In Re: Application of USA Springs, Inc. for a Large Groundwater Withdrawal Permit and  
Approval of Bottled Water Source

**TOWN OF NOTTINGHAM SELECTMEN'S NOTICE OF APPEAL UNDER**  
**ENV-WS 389**

Technical Comments on the July 18, 2002 Preliminary Hydrologic Characterization in  
Support of a Large Groundwater Withdrawal Permit Proposed USA Springs Bottling  
Plant – by Gradient Corporation

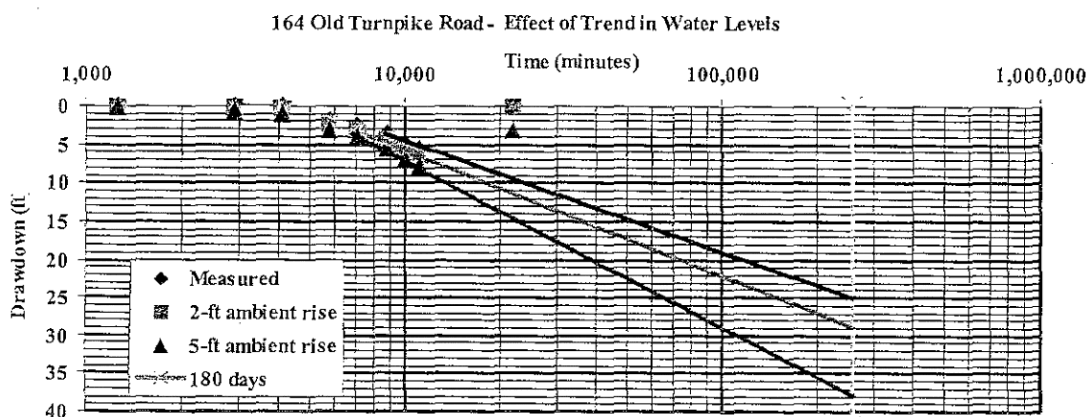
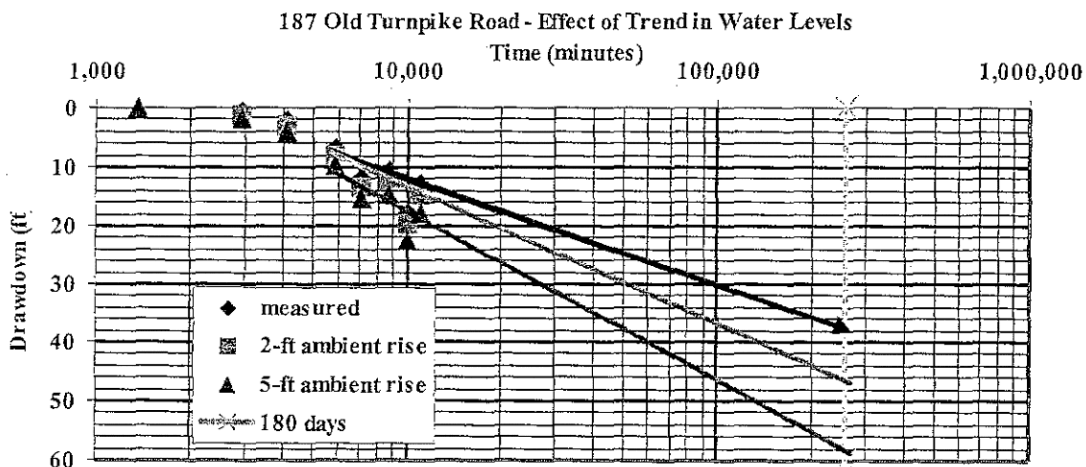
In Appendix H, the estimated drawdown for wells USA-1 and USA-2 appear unsustainable. The plots are steep, and are predicted to come close to the identified water-bearing fractures. The estimated drawdowns are well greater than half of the well depth; a common industry recommended maximum drawdown in production wells is no more than half the water depth in the well. The predicted drawdown in USA-4 is below all but one of the water-bearing fractures identified in the drilling logs. Because of these trends and the fact that there is strong well interference and that the wells did not stabilize during the pumping test, the requested 309,600 gallons per day is unsustainable. Overall, the prediction of the long term drawdown in these wells made in the report is optimistic because the large drawdowns in these wells will accelerate the well losses. This means that the drawdown predictions made in Appendix H, by drawing a straight line on a semi-log plot of drawdown versus time, assume that well losses with increasing drawdowns are constant. This contradicts common understanding of well losses. The increasing drawdown in the production wells with time will be magnified due to the non-linear well loss terms. These non-linear terms could have been developed from the step test data and used to make the long term drawdown predictions.

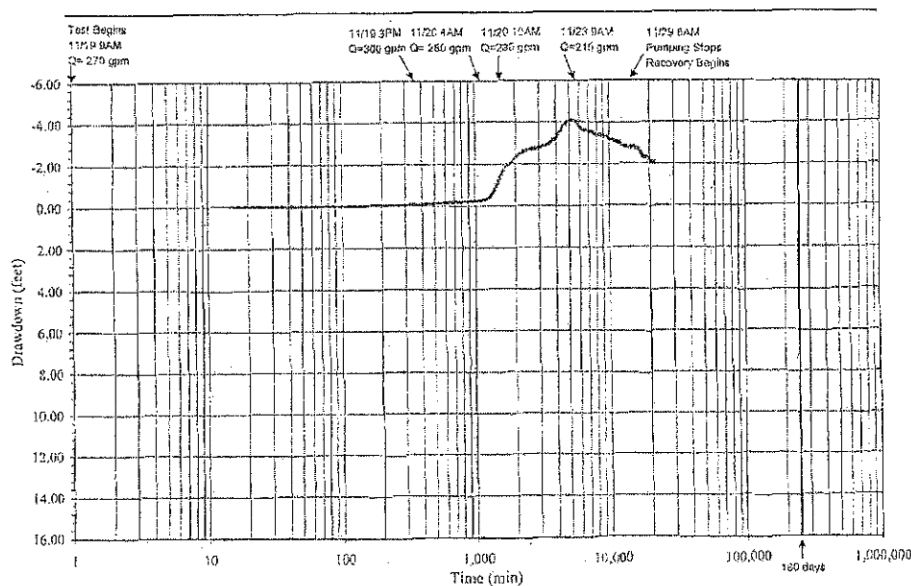
Figure 3-13 does not agree with fig 3-14, especially when employing the rose diagram. The zone of drawdown is underestimated

On-Site Well Groundwater Drawdown Analysis with Pressure Transducer Data  
P-25

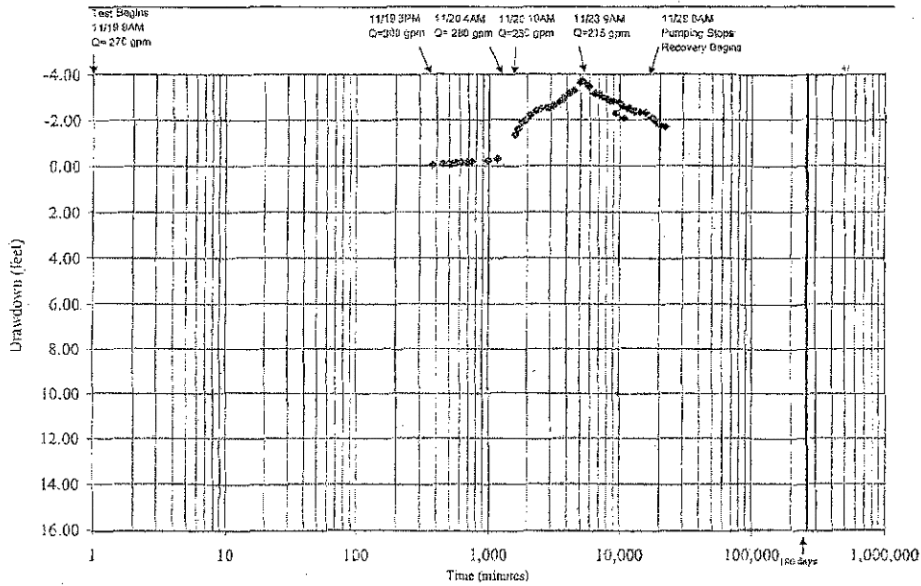
Page 36 states that, "no to minimal adverse impacts will occur at private wells located within the Study Area." However the data in the report, as well as what was collected prior to the pumping test does not support this. The report makes this conclusion based on the fact that no adverse impacts or effects were reported during the pumping test. Given the fact that the test was performed in late fall and the fact that there was substantial rain before and during the pumping test: during the pumping test, demands on private wells were very low compared to summer months and time periods when water levels are lower. In addition, the report did not factor in the effects of changes in ambient water levels (due to the recent precipitation) on private well water levels during the pumping test. This has a major implication as identified in the following three plots. In monitored bedrock wells far from the USA wells, water levels rose 2 to 5 feet over the

pumping test. If a uniform rise in water levels of 2 to 5 feet is applied to monitored wells that did exhibit drawdown, there is a dramatic difference in the projected water levels at 180 days. In the case of the three wells shown in these figures, the long term drawdown almost doubles. Another reason why adverse impacts and effects to private wells cannot be assessed at this time is because there have been no pumping tests of the homeowner wells. The well yields presented in table 4-1 are generally those provided by drillers at the time of well construction. Such data are often unreliable. All in all, at the requested pumping rate of the USA wells (215 gpm or 309,600 gpd), no conclusion at this time can be reliably made that adverse impacts to private wells will not occur. Wells along Old Turnpike Road seem particularly at risk for this pumping rate. The solutions proposed to mitigate these effects may not work. In addition, the large drawdowns in these wells will require these residents to pay more in energy costs to pump their water (not only to lift the water, but due to lower pump efficiency by operating at lower efficiencies). These are adverse effects that also require mitigation. Existing pumps at these homes may not be sized to yield as much water given the added drawdown
